SUBJECT: AMENDMENT NO. 181 TO FACILITY OPERATING LICENSE NO. NPF-3  
(TAC NO. M86933)

DAVIS-BESSE NUCLEAR POWER STATION, UNIT NO. 1

ATTACHMENT TO LICENSE AMENDMENT NO. 181

SAFETY EVALUATION BY THE OFFICE OF NUCLEAR REACTOR REGULATION  
RELATED TO AMENDMENT NO. 181 TO FACILITY OPERATING LICENSE NO. NPF-3

**Figure 3.9-1  
Burnup vs. Enrichment Curves For  
Davis-Besse Spent Fuel Storage Racks**

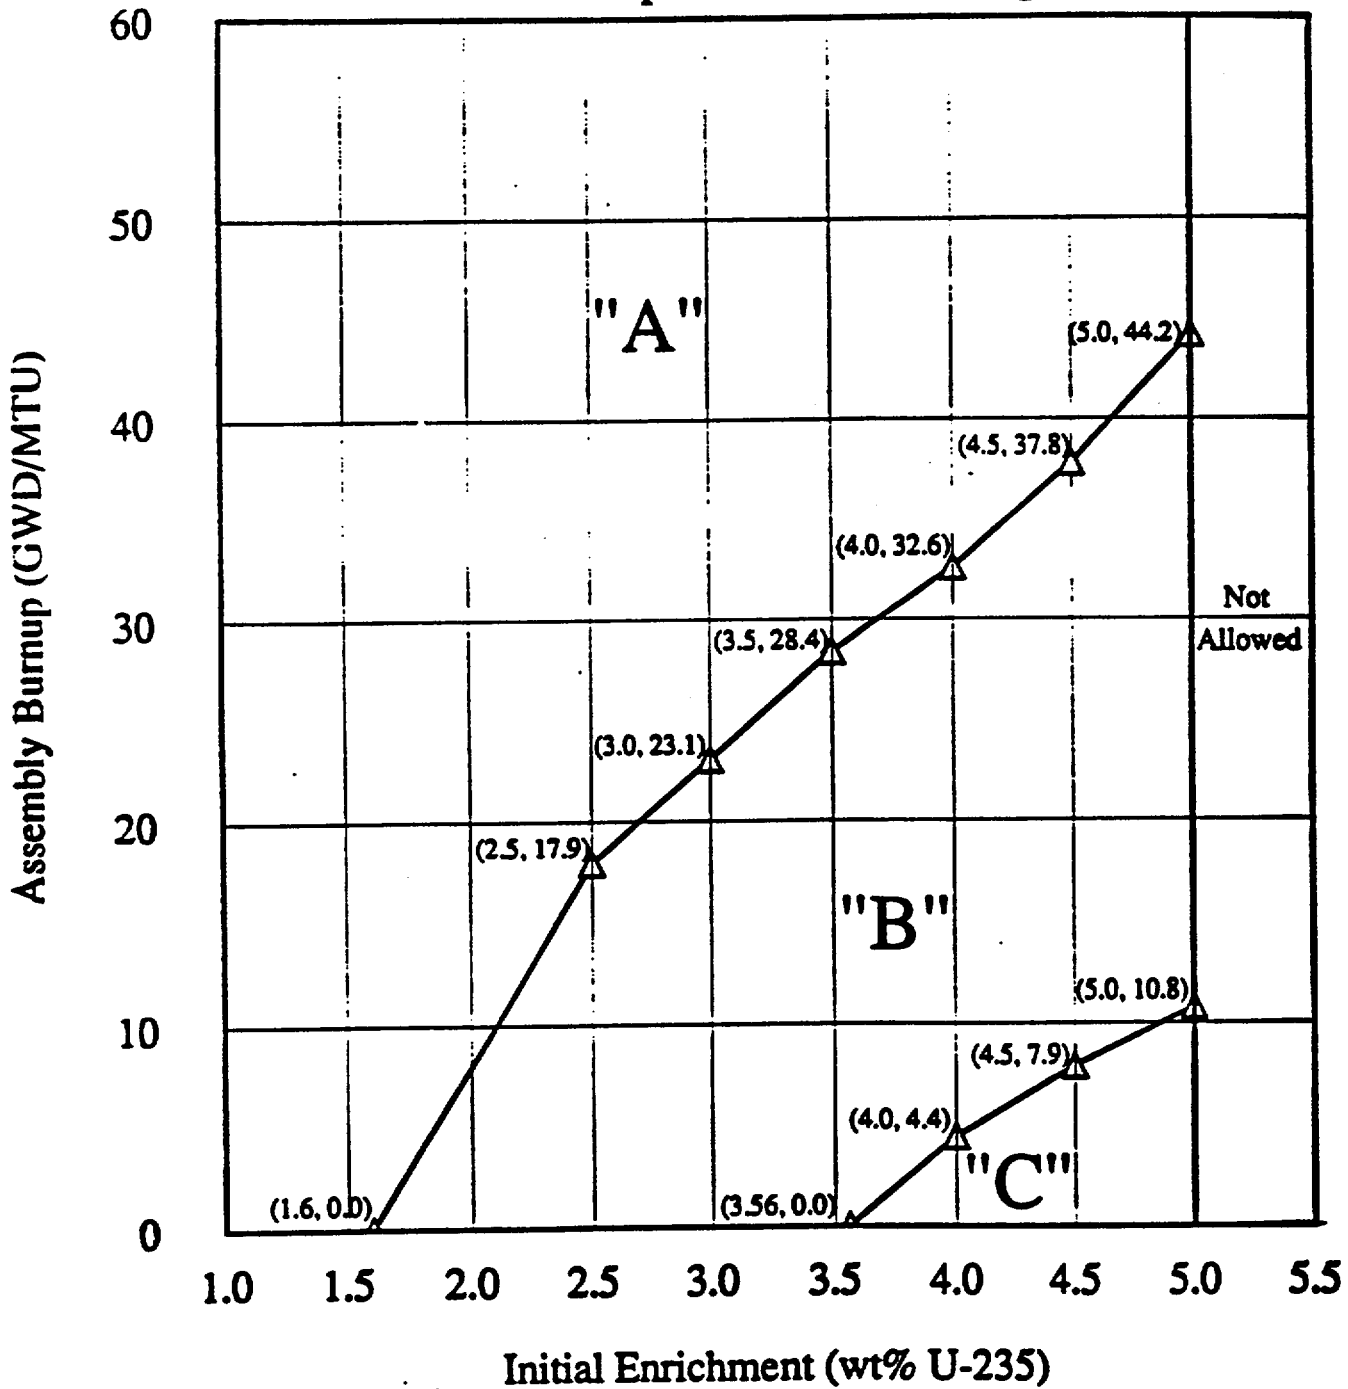
By letter dated June 23, 1993, as supplemented on October 5, 1993, Toledo Edison (the licensee), requested changes to the Davis-Besse Nuclear Power Station, Unit 1 Technical Specifications (TS) to reflect storage of new and spent fuel of higher enrichment. The existing TS Figure 3.9-1, "Burnup versus Enrichment Curve for Davis-Besse Spent Fuel Storage Racks," limits the initial enrichment of U-235 fuel that can be stored at the site to 3.8 weight percent (wt%). The requested TS change would revise TS Figure 3.9-1 to reflect the storage of higher enriched fuel of 5.0 wt%. The licensee is also proposing to revise TS 5.6.1.1 and TS 5.6.1.2 to add an appropriate cross-reference to the TS 3.9.13 description of the spent fuel storage racks, and to reflect the limitation in the description of the new fuel storage racks.

uncertainties, the licensee also included an additional 5-percent penalty to the burnup curves (TS Figure 3.9.1) to account for measurement uncertainties in assembly-average burnup, and to ensure that all KENO-IV calculations that included depleted fuel assemblies also assumed bounding burnable poison effects.

Fuel storage in the Davis-Besse SFSR is based on the checkerboard pattern in which highly enriched, low-burnup assemblies are interspersed with low-enriched, high-burnup assemblies. As in previous NRC-approved criticality analysis, three categories of fuel assemblies were determined. Category A designates fuel assemblies of lowest reactivity; these can be stored in the SFSR without restriction. Category B designates fuel assemblies of intermediate reactivity and can be stored in any location in the SFSR except directly adjacent to a Category C assembly. Category C designates fuel assemblies of the highest reactivity; these can only be stored adjacent to Category A fuel assemblies and/or locations not containing fuel assemblies. Data submitted by the licensee as part of TS Figure 3.9.1 indicate the three designated regions. The licensee also conducted bounding calculations of possible permitted combinations of the loading patterns subject to the rules stated in the preceding paragraph. In all cases, the value of the maximum  $K_{eff}$  obtained was less than 0.95. This includes all uncertainties, biases, and penalties as defined in the preceding paragraphs, and assuming no soluble boron in the spent fuel pool. The licensee is implementing a set of rigorous controls to ensure that the basis for TS 3.9.13 will be preserved during all fuel movements in the spent fuel pool. The NRC staff concludes that the analysis methods used are acceptable (subject to the rules stated above and the initial enrichment of 5 wt%) and are capable of predicting the reactivity of the Davis-Besse, Unit 1 storage racks with a high degree of confidence.

3.9.13 Fuel assemblies stored in the spent fuel pool shall be placed in the spent fuel storage racks in accordance with the criteria shown in Figure 3.9-1.

4.9.13.1 Prior to storing the fuel assembly in the spent fuel pool, verify by administrative means that the initial enrichment and burnup of the fuel assembly is in accordance with Figure 3.9-1.

Category "A": May be placed in any rack location

Category "B": Must not be placed directly adjacent to Category "C" assemblies

Category "C": May only be placed directly adjacent to Category "A" assemblies or non-fuel locations
